MEMO

Date: December 7, 2020

Re: 185 S. RIVERVIEW STREET, Second Review of New Construction

North (Side) Elevation

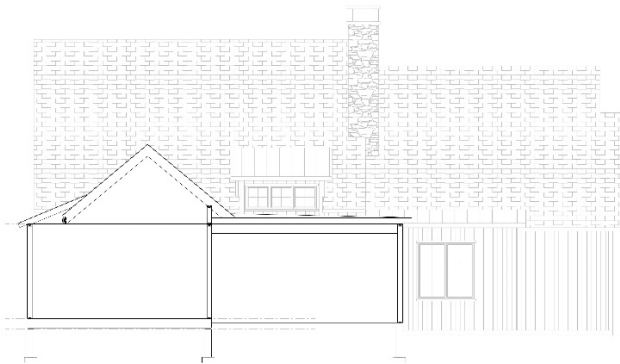
- Consider removing the shed-roof window hood over the bedroom window and making this a single window like others on the façade. In addition, provide more information regarding these windows. Six-over-six sash windows are appropriate to the historic district as well as to the hall-and-parlor house type which is the inspiration for this dwelling.

- Adjust the size of the chimney stack and the enormous chimney cap. The stone material is appropriate (and an improvement from the last submittal). Make the chimney stack more compatible with ones in the historic district, which usually had a smaller, tapered stack.

- If the siding along the kitchen extension is to be the same color as that of the main house and its other extensions, it should be of the same material—horizontal clapboard siding. Vertical siding is appropriate for the garage, as well as the change in the color of the siding. Traditionally, outbuildings were painted white, “Spanish brown” (which was a red-brown color), or left unpainted.
